Determination 2024/035

The purported refusal to grant a building consent for a skillion roof and whether it complies with E2.3.5 by way of E2/AS1

304 Jack Henry Road, Kinleith, South Waikato

Figure 1: Section view of the skillion roof design (not to scale)

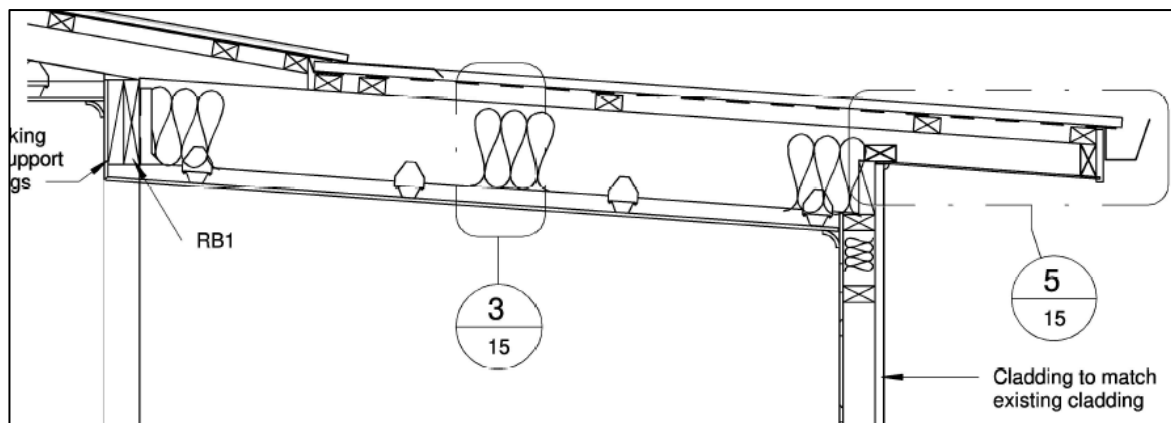
- 3.1. The designer applied for a consent for the building work, and on 21 June 2023 the authority requested further information. Regarding 'E2 Roof Cladding', the authority requested information to demonstrate:
 - a) there is adequate ventilation provided to prevent the accumulation of moisture below the cladding, and
 - b) that there is adequate separation provided between the underside of the substrate and insulation to prevent transfer of moisture, and
 - c) that the roof cavity is sealed from penetrations from spaces below.

The plans are to show that there is an adequate number of air changes to ensure the enclosed roof cavity is well vented. Air flow should be shown flowing in and also venting out.

- 4.1.5. A 25mm gap has been provided on the plans between the insulation and the underlay to allow for air flow.

- 5.6. The matter to be determined is in relation to the skillion roof design and the authority's request to see ventilation in the roof cavity.
- 5.7. E2.3.5 requires that buildings be constructed in a way that does not cause condensation, fungal growth or degradation to building elements from external moisture accumulating or transferring into concealed spaces and cavities, such as roof and wall cavities. The transference of moisture can include moisture vapour movement and interstitial vapour diffusion through building materials, and is a concern with skillion roofs in relation to E2 compliance.

5.18. The designer has noted that they have specified a 25mm gap on the plans between the roof underlay and insulation product to allow for air flow. As described in previous determination 2021/012, this gap prevents insulation from becoming

damp by absorbing moisture that might be held by the underlay.⁷ If the insulation were to become wet, there is an increased risk in further condensation, fungal growth and damage to building elements.

- 5.19. However, air flow in and through this space to dry any moisture will be limited in low pitch roofs, such as skillion roofs. If the roof cladding is constructed to E2/AS1, the requirements are to turn down the bottom edges of the roof cladding to the gutter, as per E2/AS1 cl. 8.4.14 and to have stop-ends to the top end of the cladding, as per E2/AS1 cl. 8.4.13, where in this case it is also flashed to the existing roof structure. These requirements will reduce the natural air flow accessing and moving through the entire roof cavity. Any addition of a purlin being installed at the end of the run against the fascia board – as is shown in the eaves detail on the plans in this instance – will also restrict air flow.

5.14. I consider that the roof design complies with E2/AS1, so therefore compliance with E2.3.5 is achieved.

- 7.1. In accordance with section 188 of the Building Act 2004, I determine that the design of the skillion roof complies with E2.3.5 by way of the acceptable solution E2/AS1, and I reverse the authority's purported decision to refuse to grant the building consent.
